MSEX2014A-03

S E R V I C E N O T E

MSEX2014A – Oscilloscope, Mixed Signal, 4+8 Channel,
100MHz

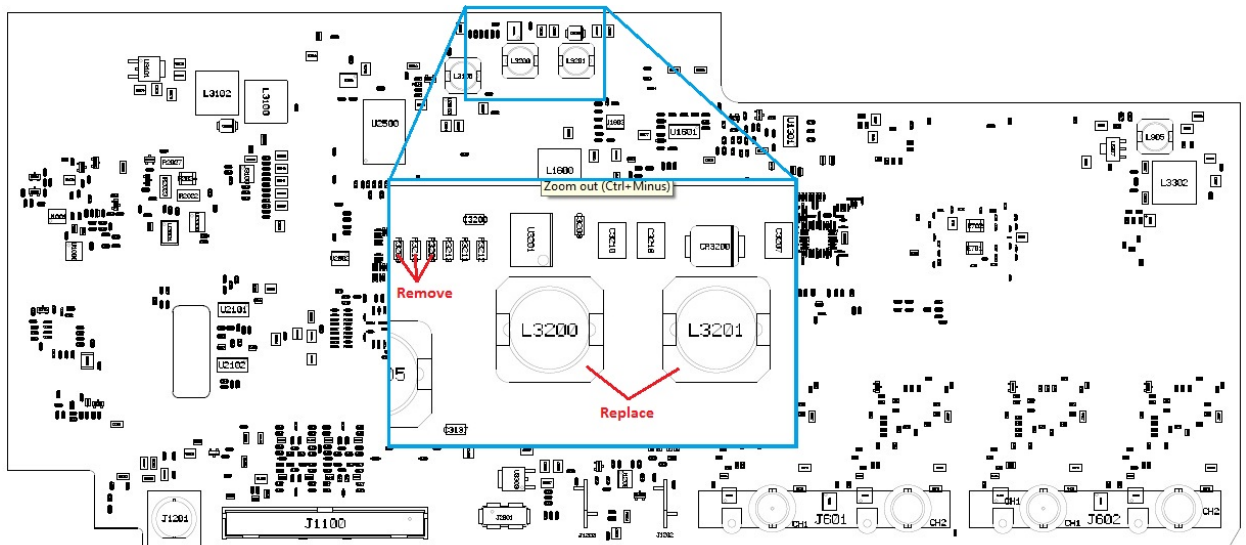
With the oscilloscope power turned on and while under normal operation, the unit emits a hissing noise.

2. As the picture indicates, remove the three resistors (0699-7209, 1 Ohm) located at R3208, R3209, and R3210. They are not to be replaced.
3. Remove as well the two inductors (9140-6474, 100uH) located at L3200 and L3201 and replace them with inductors with part number 9140-6151 (68 uH).
4. Re-assemble to the point where the unit could be powered up to verify that the hissing is indeed gone. If the hissing is not gone, please, check modifications.
5. When the hissing is gone, put oscilloscope back together.
